## HISTORIC AND DESIGN REVIEW COMMISSION

**HDRC CASE NO:** 2018-632  
**ADDRESS:** 9211 S PRESA ST  
9159 S PRESA ST  
**LEGAL DESCRIPTION:** NCB 10917 P-106 1.494 AC NCB 10918 P-107 .506 AC  
NCB 10918 BLK LOT P-106  
**ZONING:** MF-33, H  
**CITY COUNCIL DIST.:** 3  
**DISTRICT:** Mission Historic District  
**APPLICANT:** Stedman Grigsby David Lefton  
**OWNER:** San Juan Mission Villas, Ltd.  
**TYPE OF WORK:** Construction of two, multi-family residential structures and an amenity structure  
**APPLICATION RECEIVED:** December 12, 2018  
**60-DAY REVIEW:** February 20, 2019  
**REQUEST:**

The applicant is requesting conceptual approval to construct a multi-family residential development to feature 102 residential units. The proposed development is to feature two, three story residential structures as well as a one story clubhouse.

SAN JUAN MISSION VILLAS-  
Site plan overlay

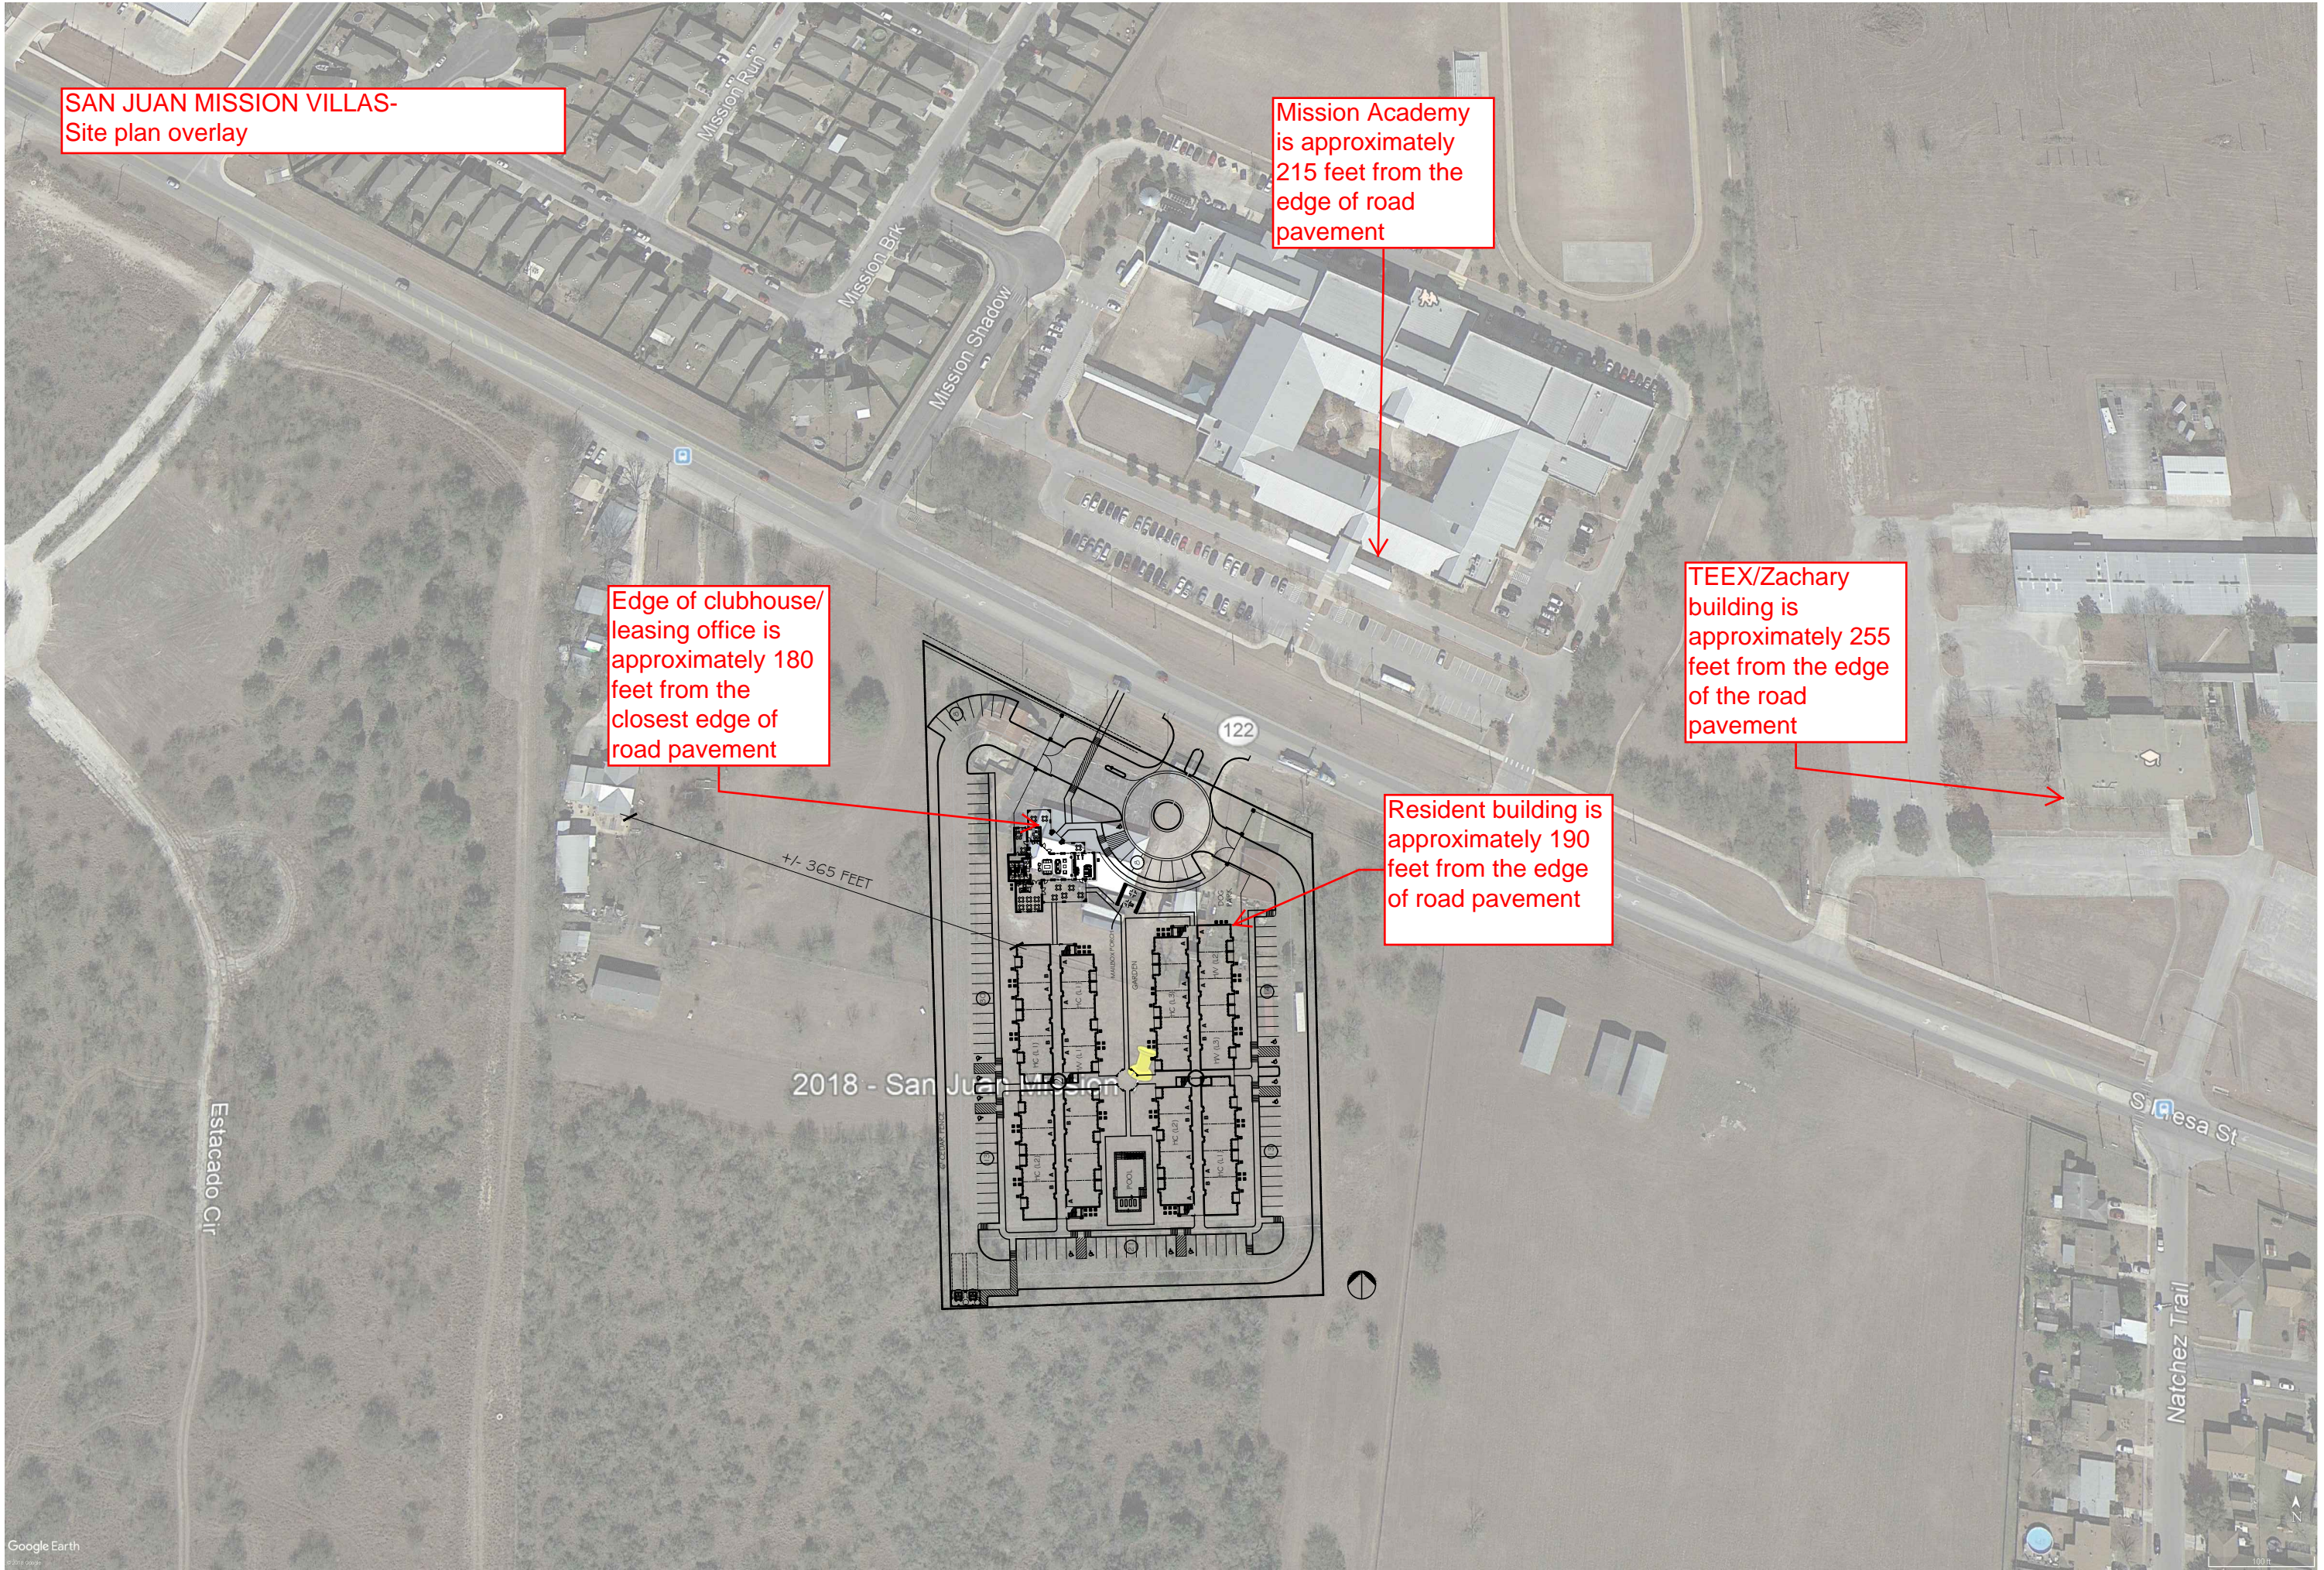
- h. **VEHICULAR ACCESS** – The Mission Design Manual notes that driveway widths should not exceed twenty-four (24) feet in width. The applicant has not specified a width at this time, but per the site plan, the width appears greater than 24 feet. The applicant has noted that the existing, landscaping island will be increased to reduce the perceived width of the entrance drives.

**COMMENTS/CONCERNS:** JM: OVERVIEW OF PROPOSAL, UPDATES TO DESIGN  
VS ORIGINAL DESIGN, OVERVIEW OF STAFF'S PREVIOUS COMMENTS AND  
HOW THEY'VE BEEN ADDRESSED BY DESIGN TEAM / DISCUSSION WITH  
COMMITTEE. EG: A VERY MUCH NEEDED DEVELOPMENT - FOOTPRINT  
OKAY. JM: WIDTH OF ISLAND BETWEEN ENTRANCE/EXIT WILL BE INCREASED  
TO BE LESS IMPACTFUL TO SITE / PROVIDE LESS PAVING. JM: OVERVIEW  
OF MATERIALS. SC: UPDATED DESIGN IS APPROPRIATE. MG: PROVIDE  
SLIGHTLY MORE CONTEXT IN SITE AERIAL.
